**Bid No. 26-09**

**2026 Water Main Improvements and Street Resurfacing**

**ADDENDUM No. 2**

**March 30, 2026**

SCALE	1" = 20' H 1" = 2' V
PROJECT NUMBER:	PW-WMRS-2601
BID NUMBER:	26-09
ISSUED FOR:	BID
DATE:	2/9/2026
DESIGNED BY:	AA
DRAWN BY:	AA, AH
CHECKED BY:	BN
SHEET	5 OF 28

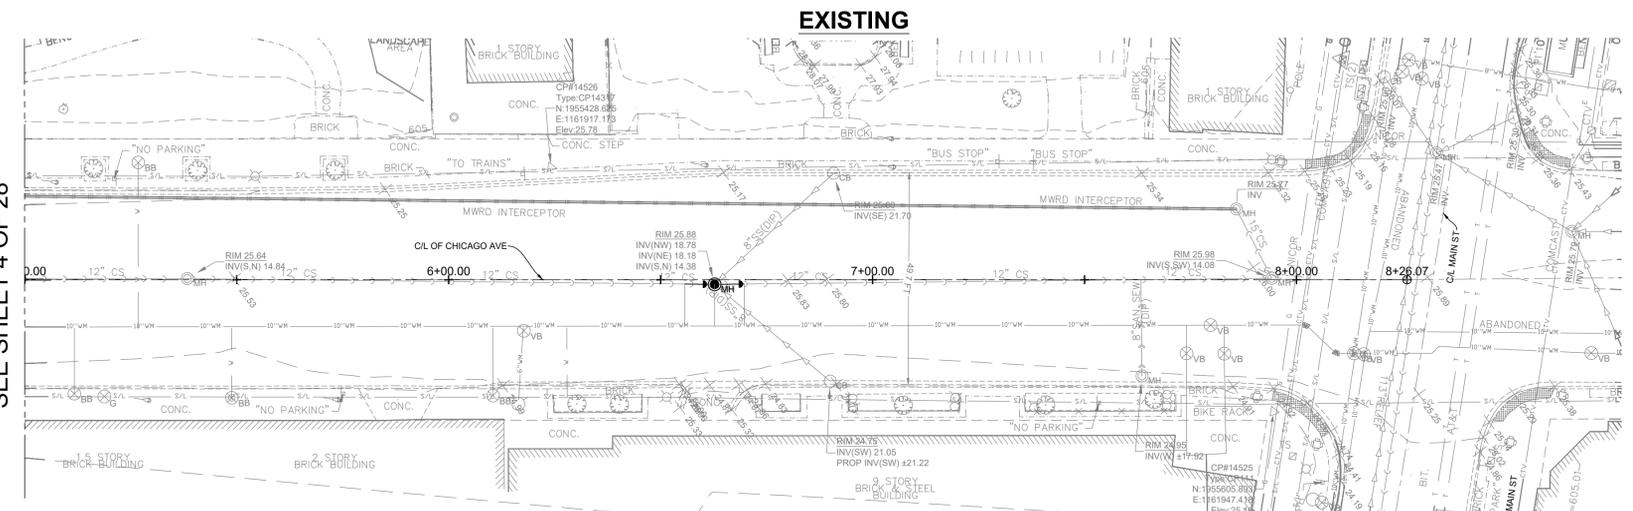
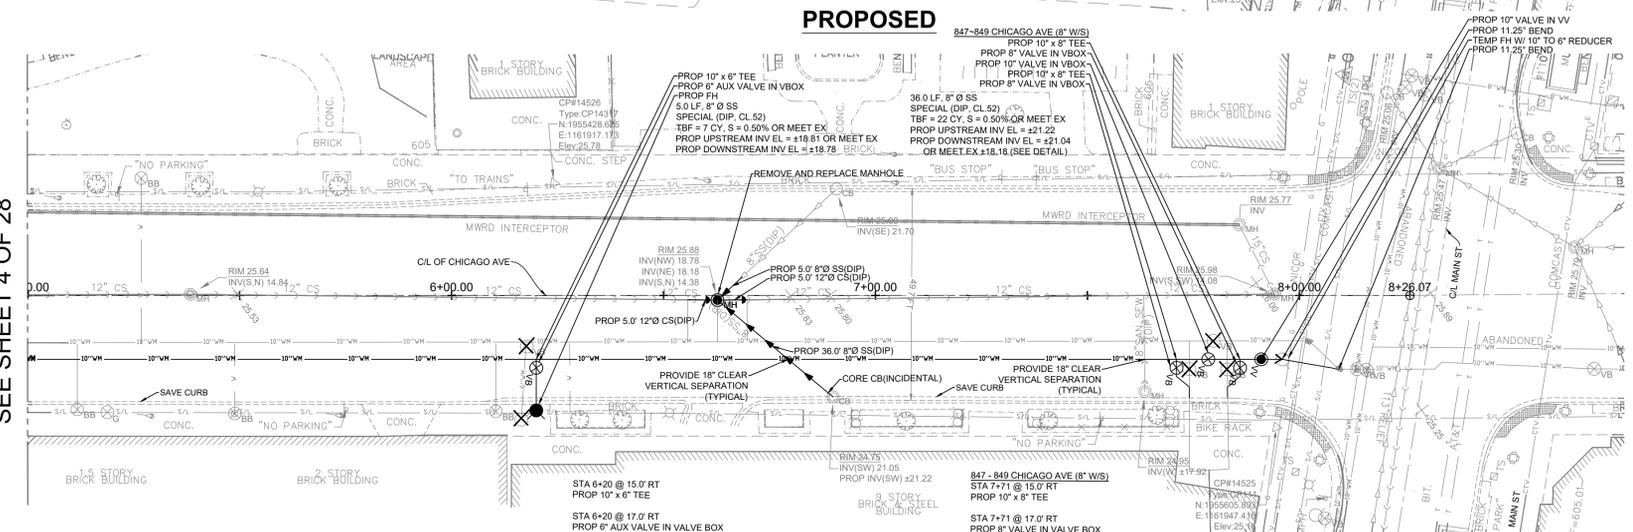
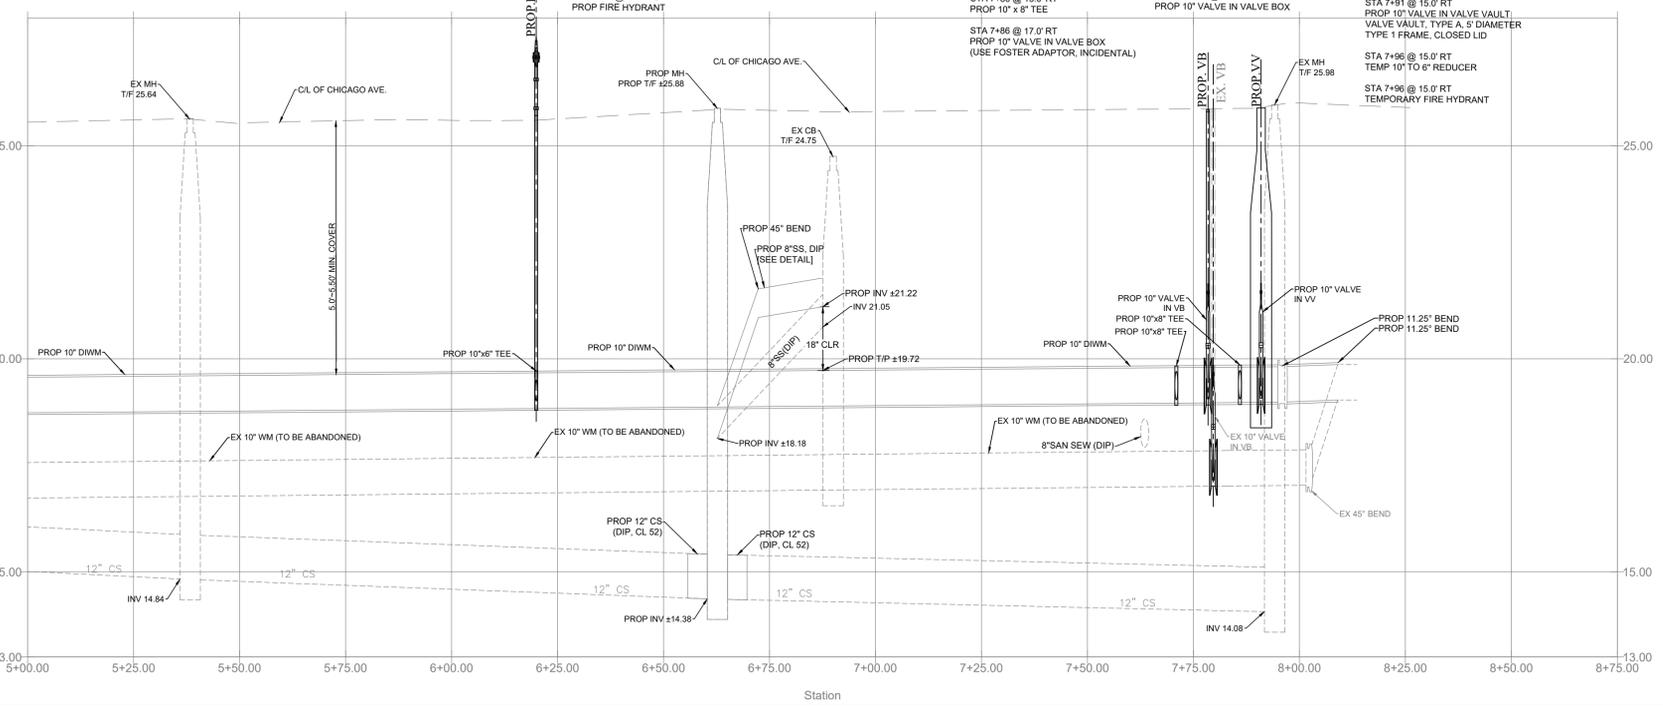
- Remove Sheet 3 of the Project Plan Set and replace it with the revised Sheet 3 attached.
- Remove Sheet 5 of the Project Plan Set and replace it with the revised Sheet 5 attached.
